**179-B-50**

**Brentwood Street**

**Community Garden (Evergreen Cemetery)**

**From:** Kwoka John J SOSB <John.Kwoka@supshipba.navy.mil>  
**To:** 'Shukria Wiar' <SHUKRIAW@portlandmaine.gov>  
**CC:** Barbara Barhydt <BAB@portlandmaine.gov>, Penny Littell <PL@portlandmaine...>  
**Date:** 5/24/2010 7:28 AM  
**Subject:** Comments on Garden Application Approval

Conditions on 6/29/09

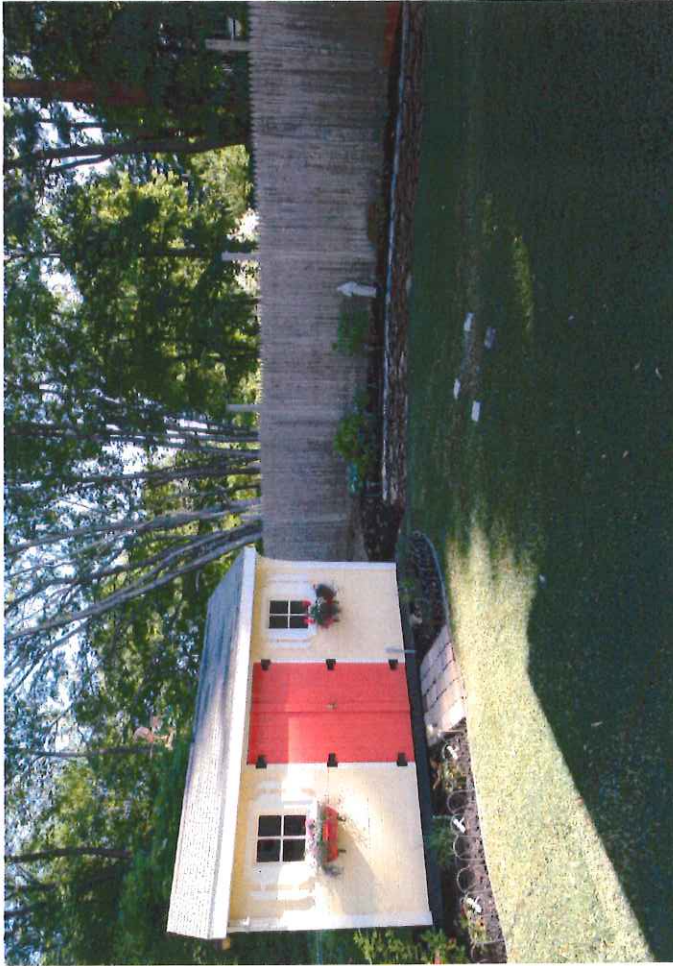
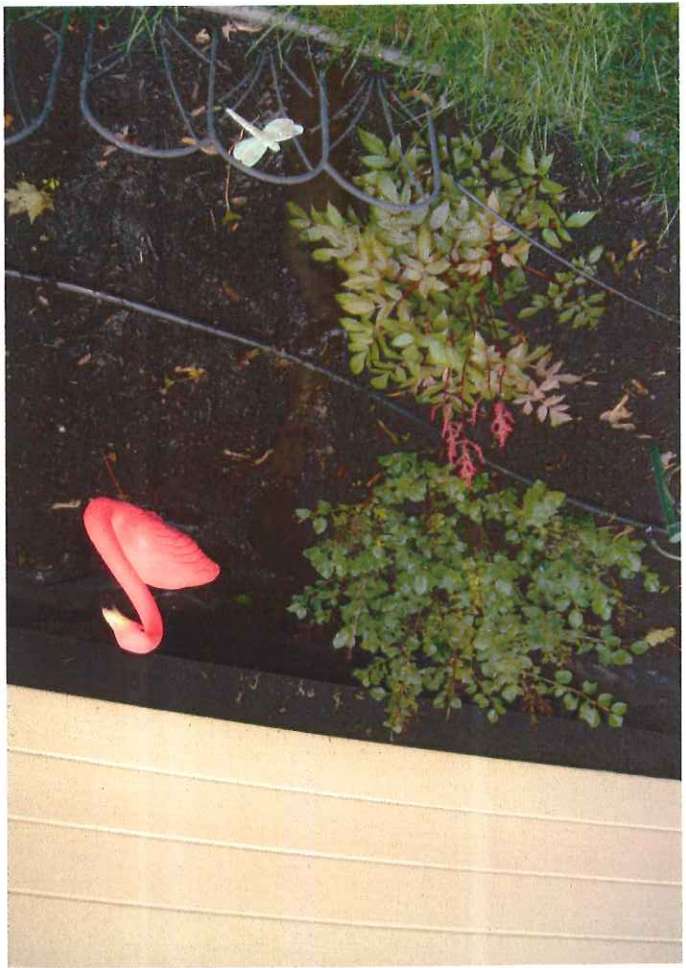
To further illustrate the impact on our property from the runoff, I will provide a series of photos and some CDs with video of the runoff entering our property at our back gate during various storm events when we meet @15:30 on the 5<sup>th</sup> of Apr 2010.
